12 June 2024

SB Civil
C/-
Laila Alkamil
Senior Planner
Williamson Water and Land Advisory

RESPONSE TO ADDITIONAL INFORMATION REQUEST – 1618 ARARIMU ROAD, PAPAURA

Sheet Title Vehicle Crossing Design - NZTA PPM: Diagram E

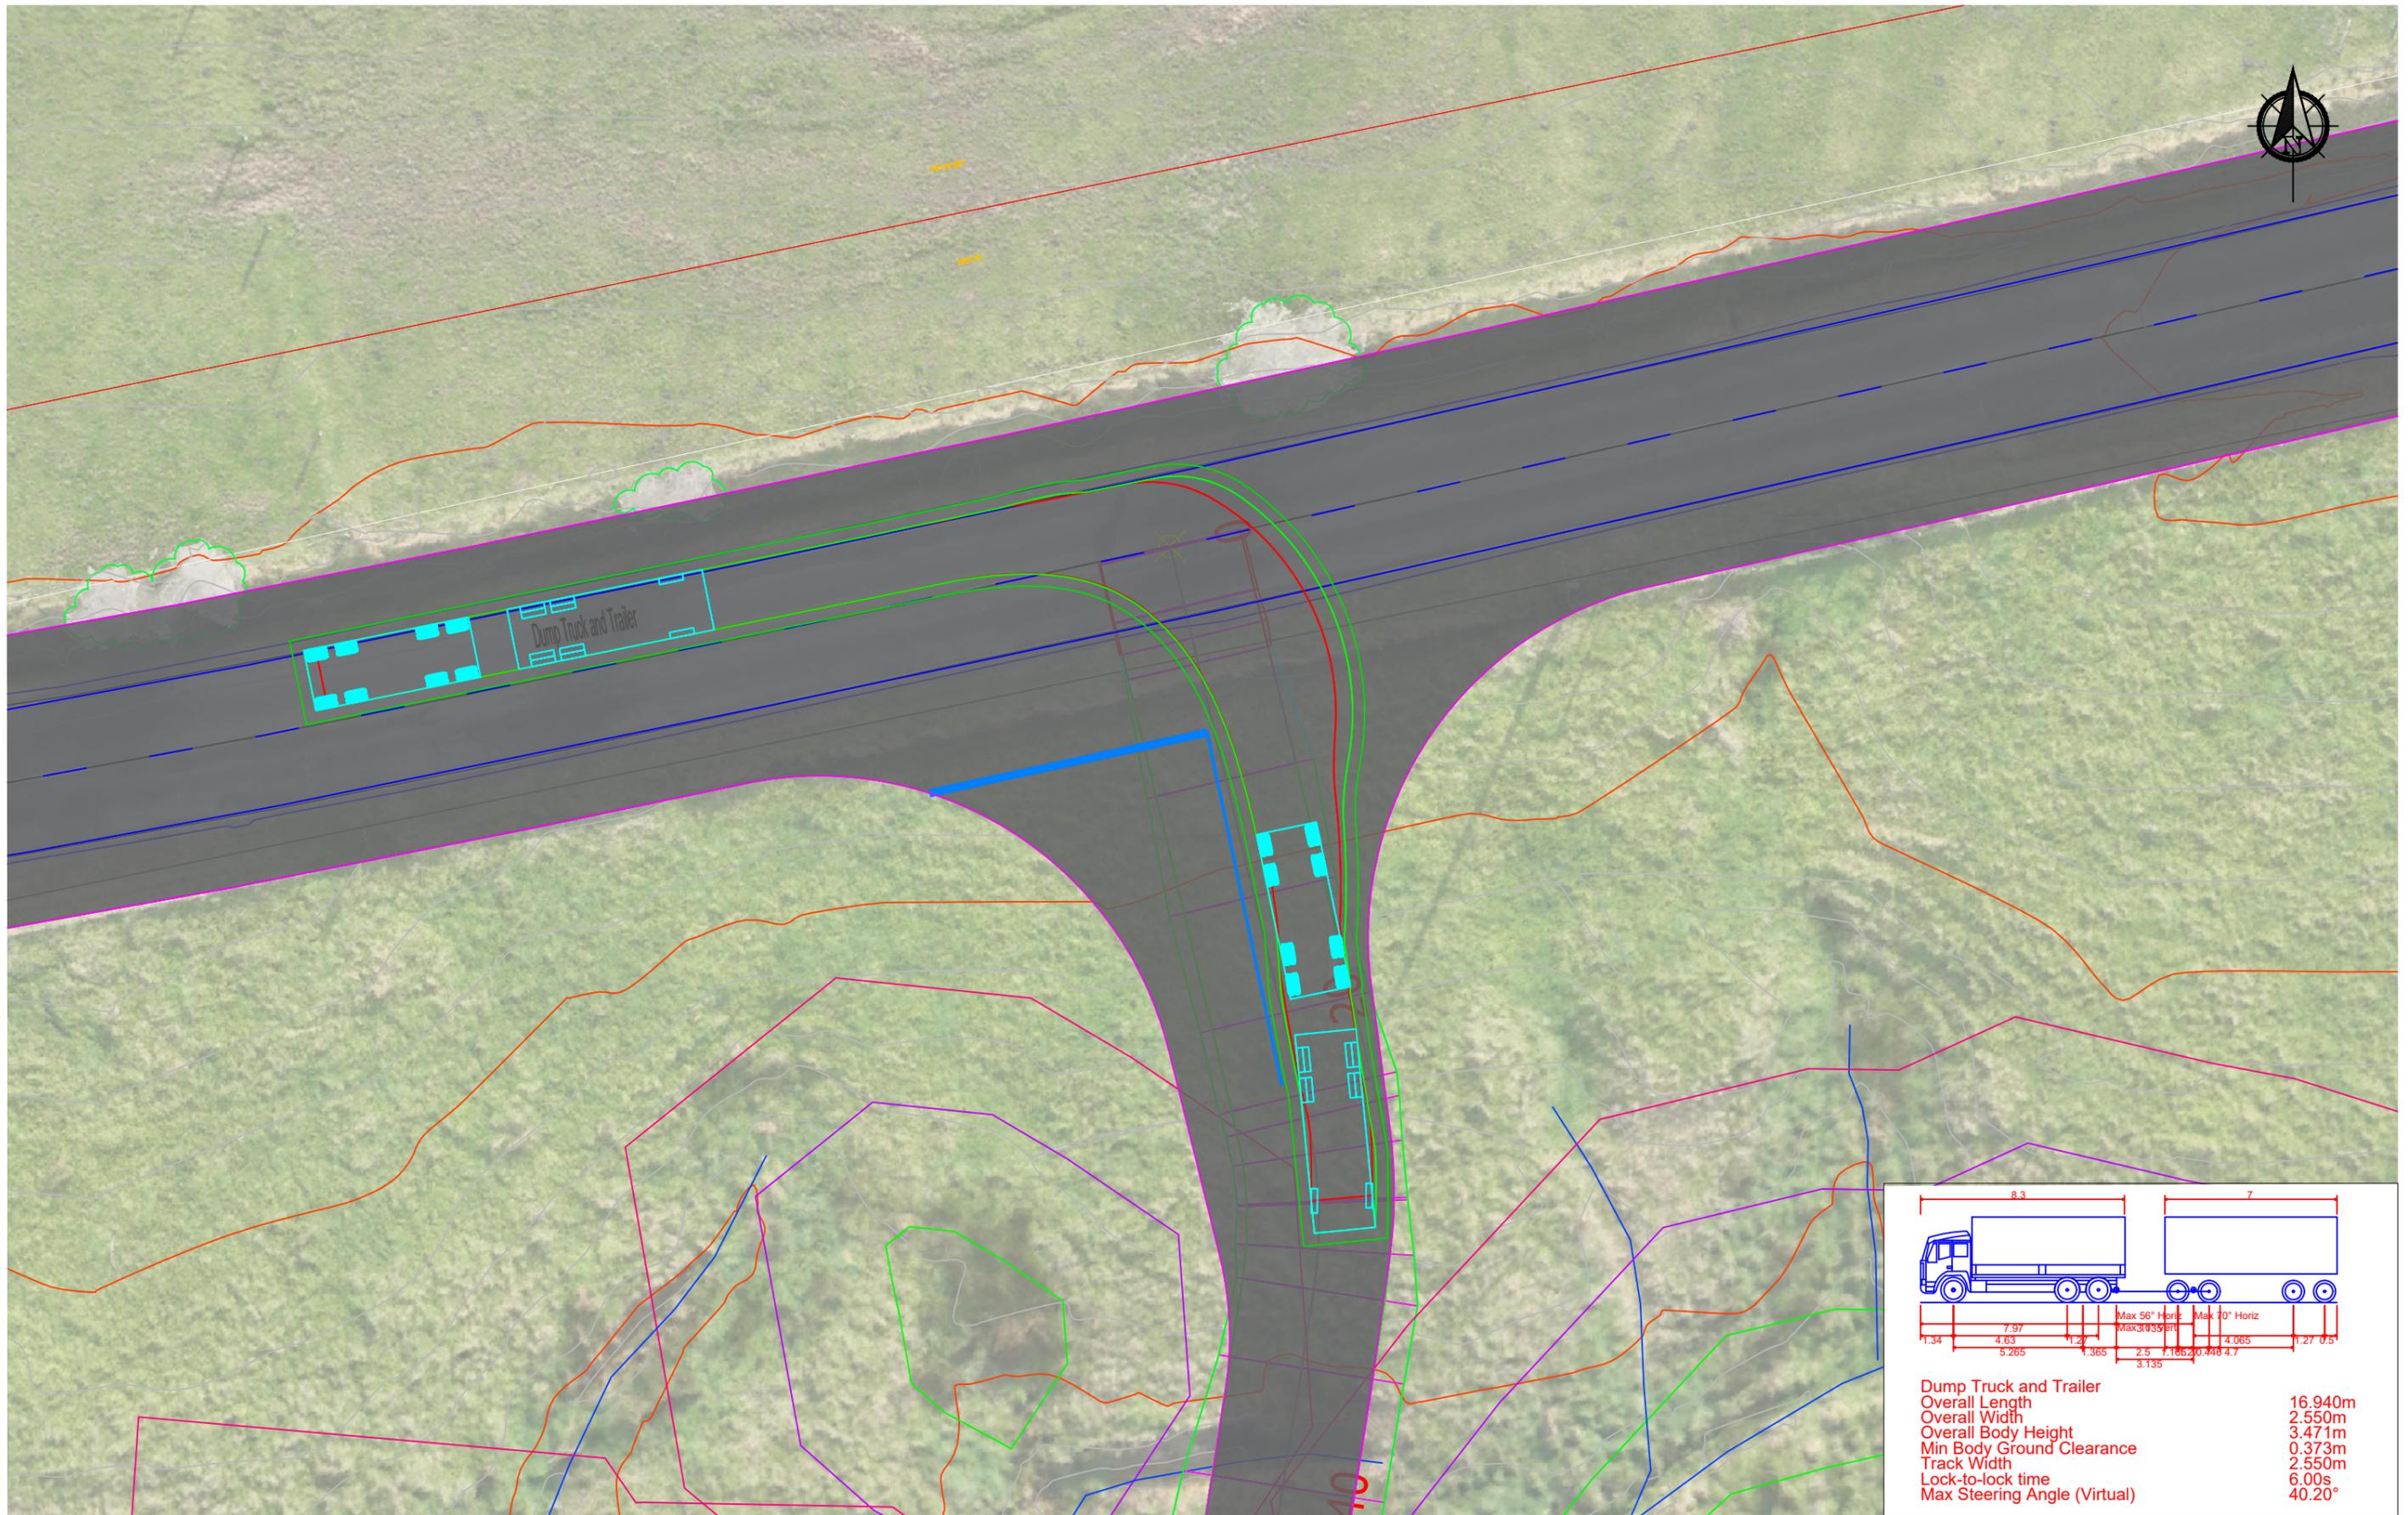
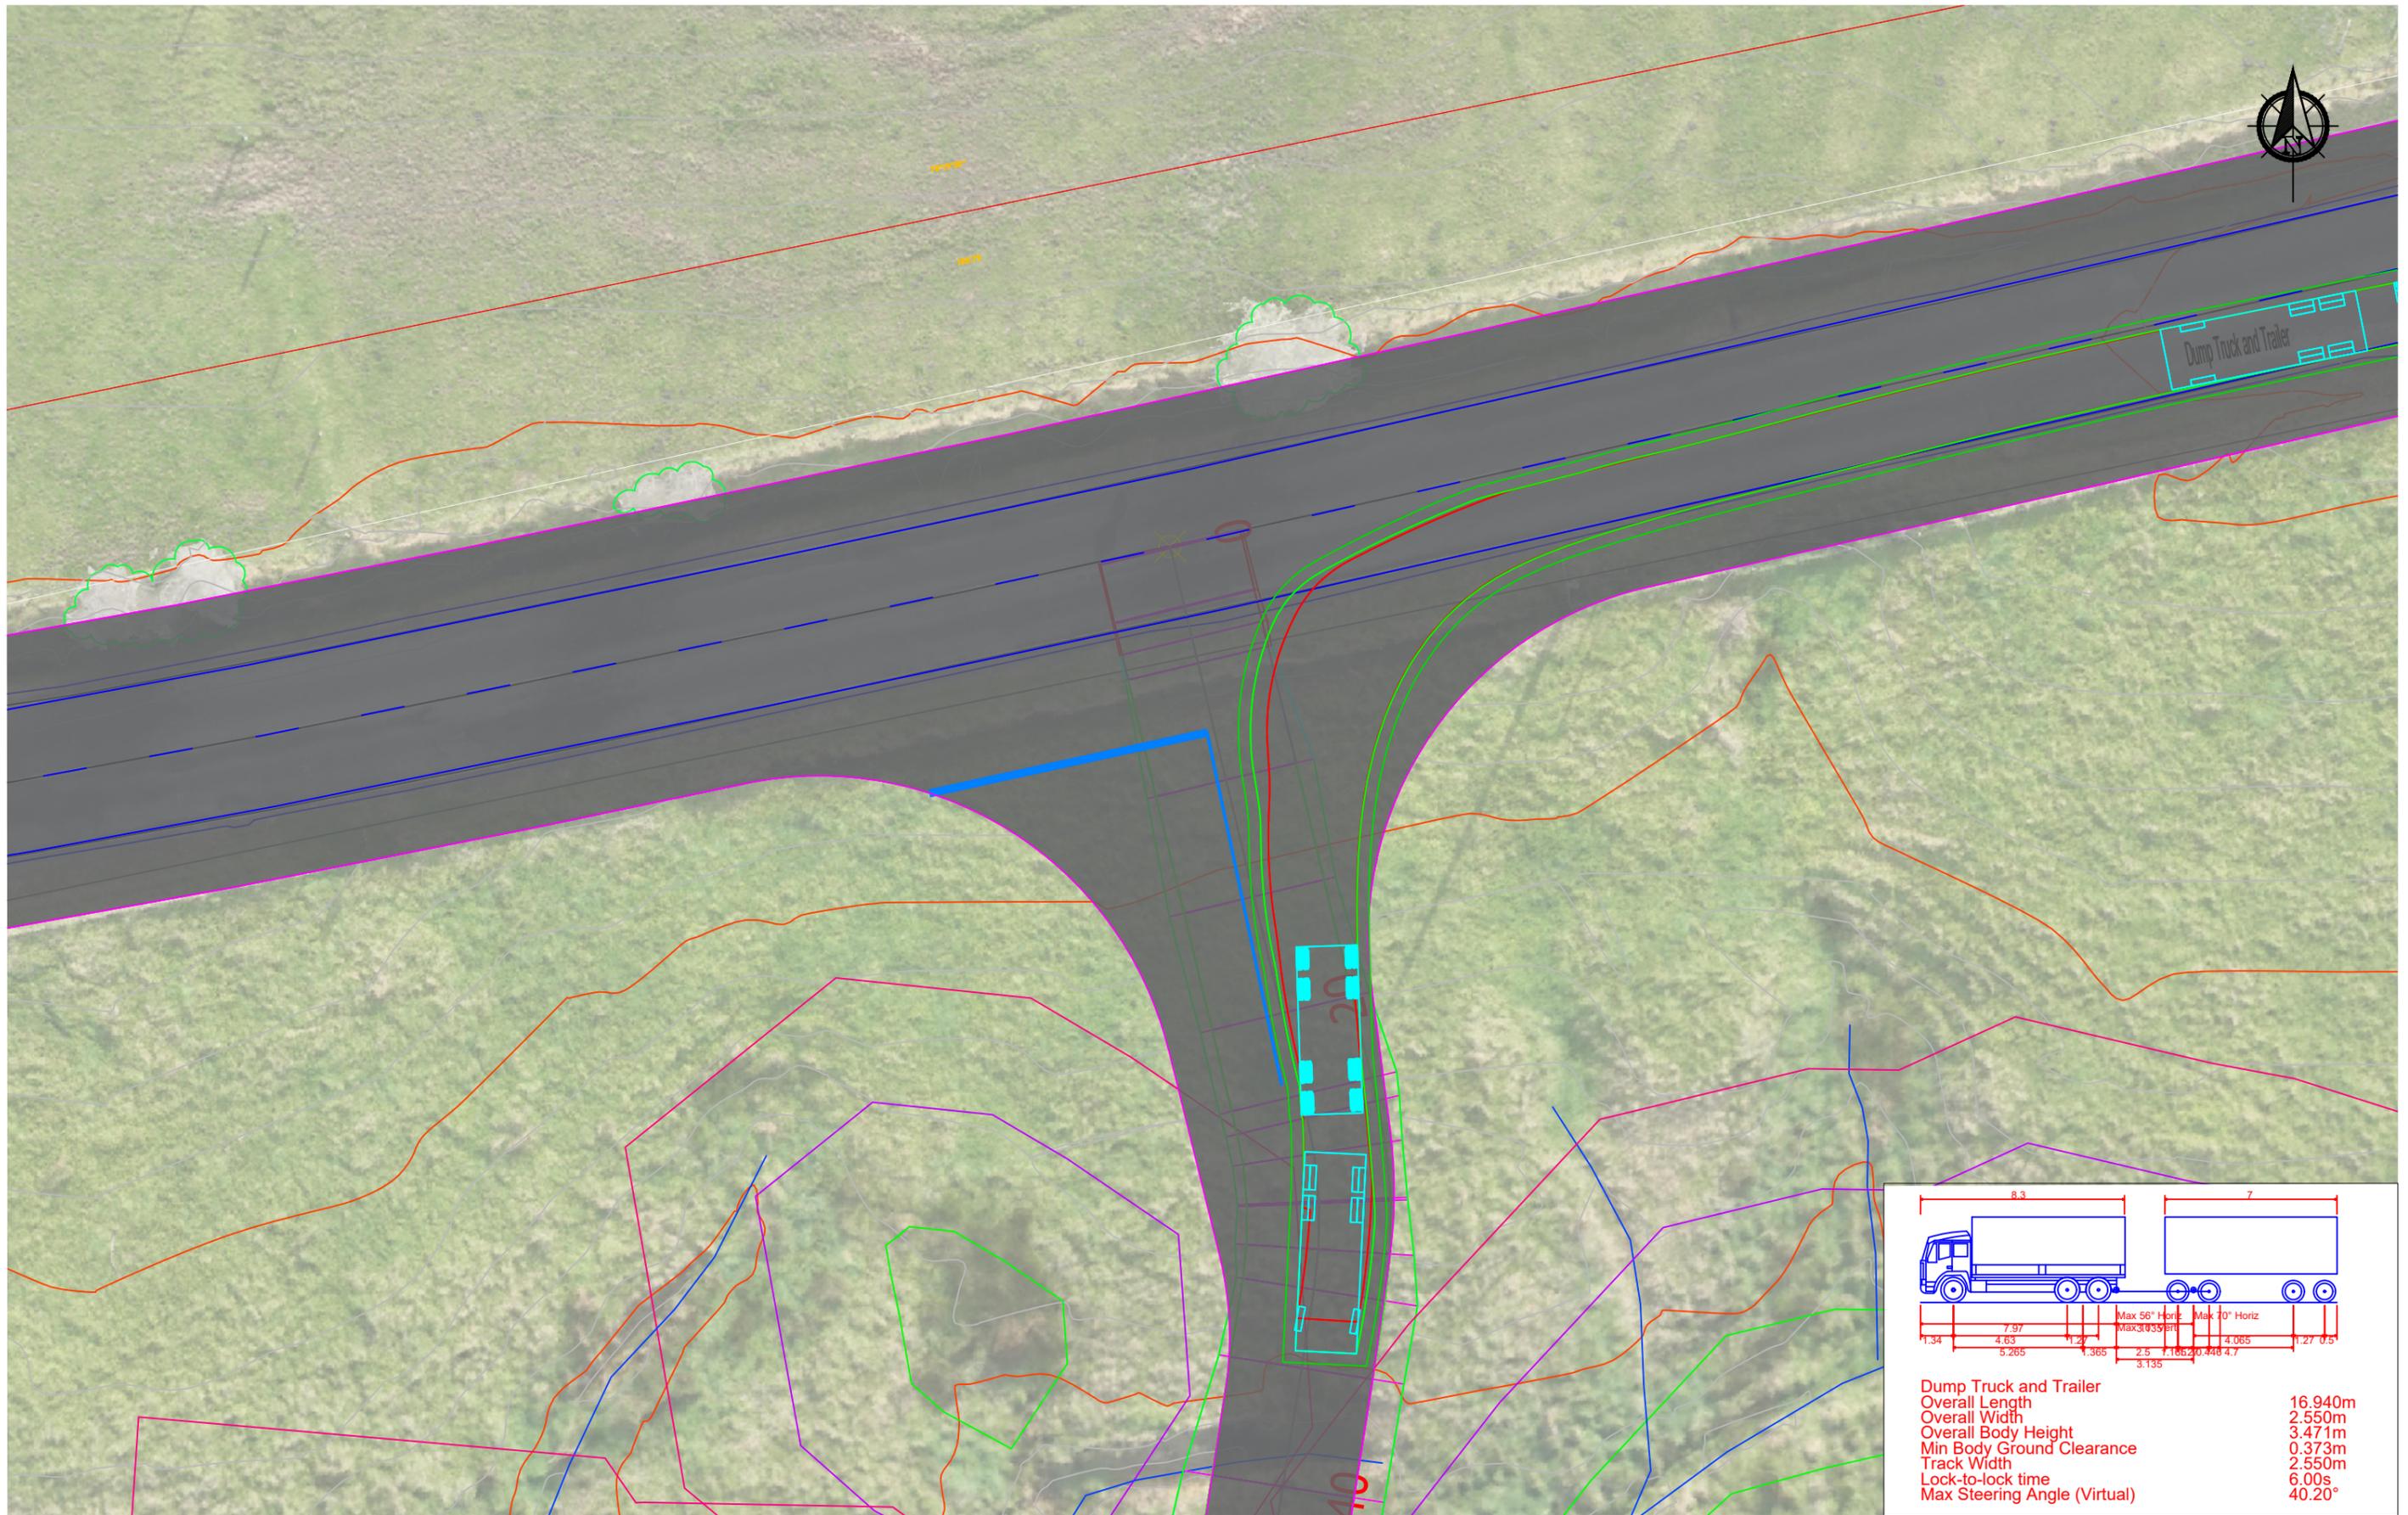
Please provide revised tracking diagrams of the 17m truck and trailer off 23m wide vehicle access after providing analysis as per NZTA's Planning Policy Manual Appendix 5B.

Updated vehicle tracking has been provided within the **Attachment** for the 17m truck and trailer, based off the vehicle crossing design as per NZTA PPM – Diagram E. It is noted that trucks can enter/exit the site with relative ease, however this is not unexpected as the increased curve radius and lane widening provides additional space. It is however noted that within increased width and radii, trucks can be expected to enter and exit the site at higher speeds compared to that of the preferred design.
